bethesda crescent

SK+I ARCHITECTURE | MRP | REALTY

1 View from Northwest (Metro Plaza)

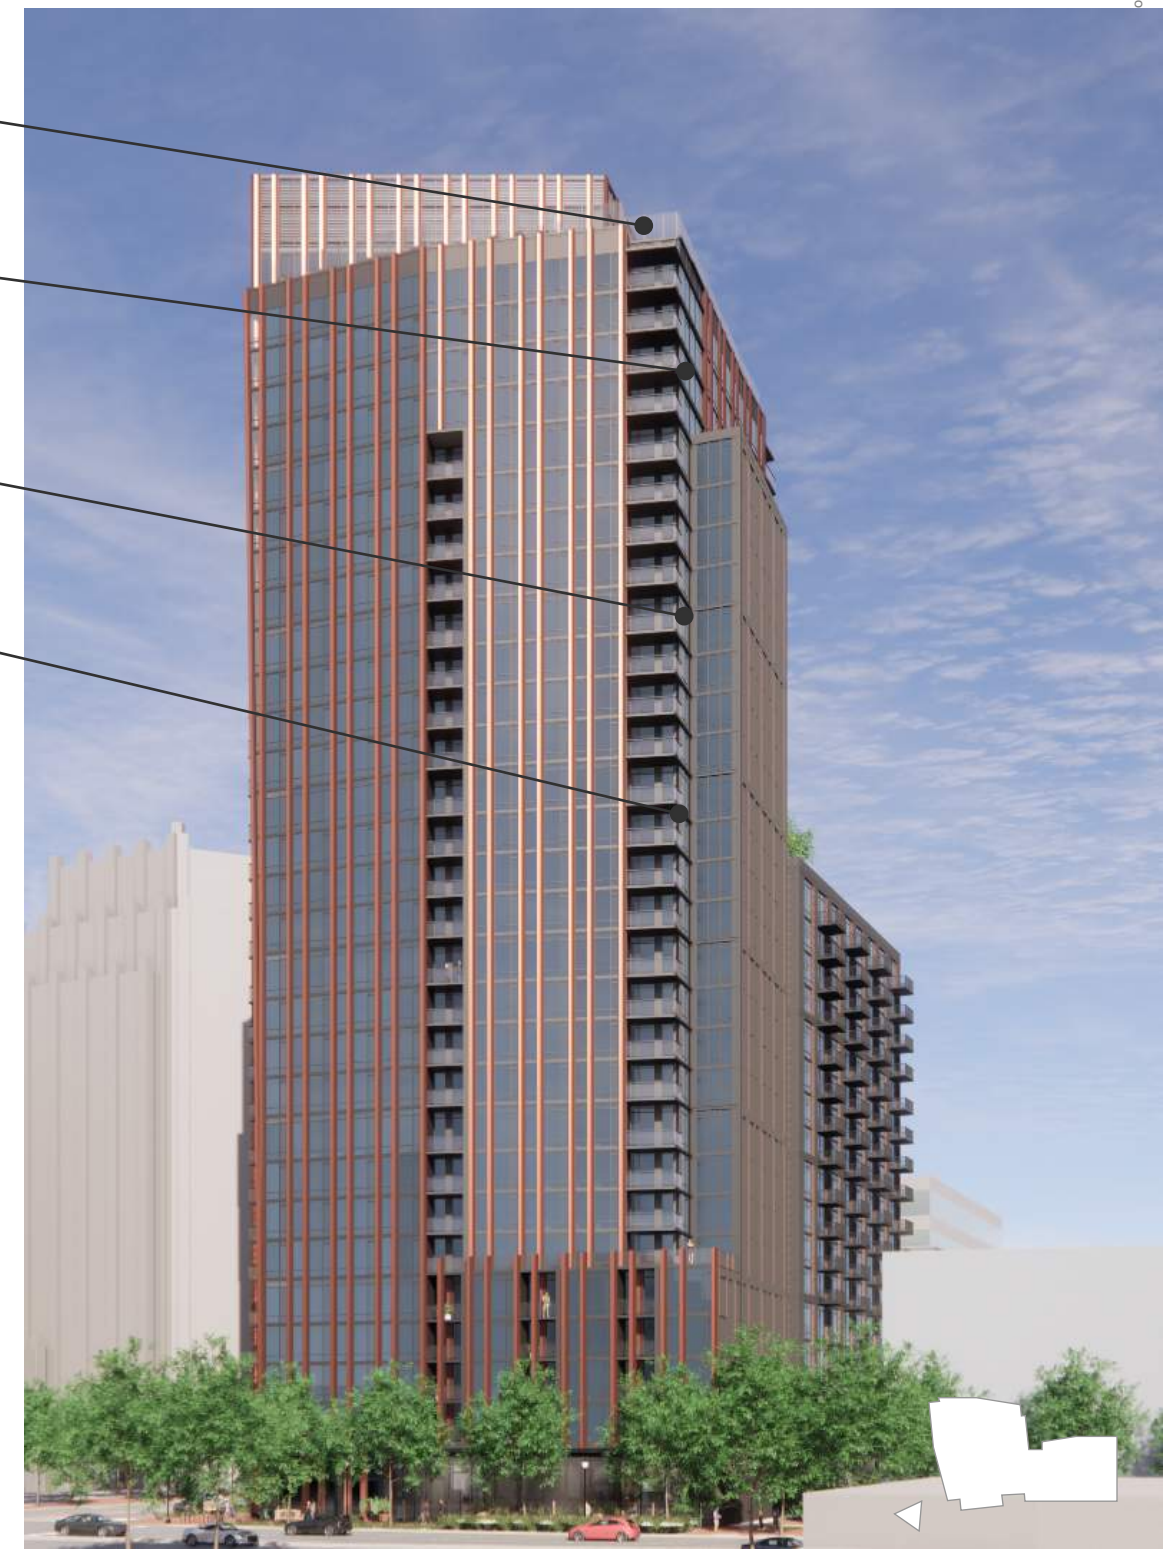
Parapet above balcony stack recessed back from main Wisconsin facade, establishing a clear separation from the folded plane.

Top 4 floor corner windows enlarged with one more bay of copper piers removed, enhancing the top reading of the tower approaching from south.

Copper Piers removed, corner windows enlarged and set back, slab edges are pronounced for a more dramatic reading. Same condition is established on the southeast corner of the building.

Corner Pier and Wingwall removed

Parapet above balcony stack recessed back from main Wisconsin facade, establishing a clear separation from the folded plane.

Corner Pier and Wingwall removed

1 View from Wisconsin heading North

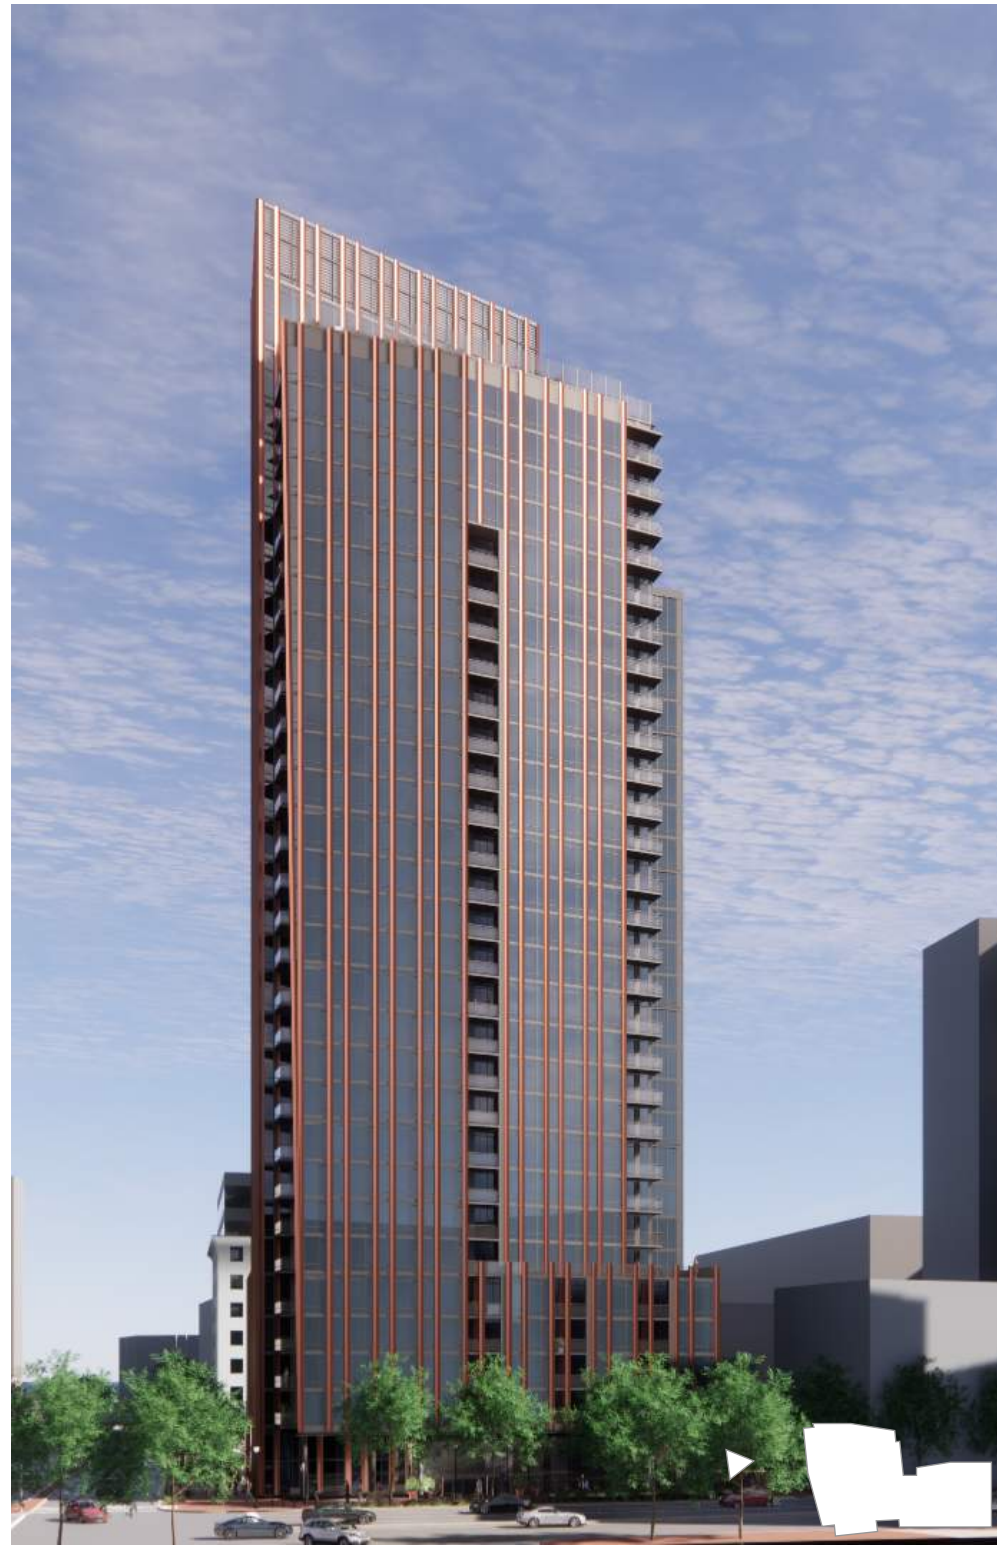
Top 4 floor corner windows enlarged with one more bay of copper piers removed, enhancing the top reading of the tower approaching from south.

Copper Piers removed, corner windows enlarged and set back, slab edges are pronounced for a more dramatic reading. Same condition is established on the southeast corner of the building.
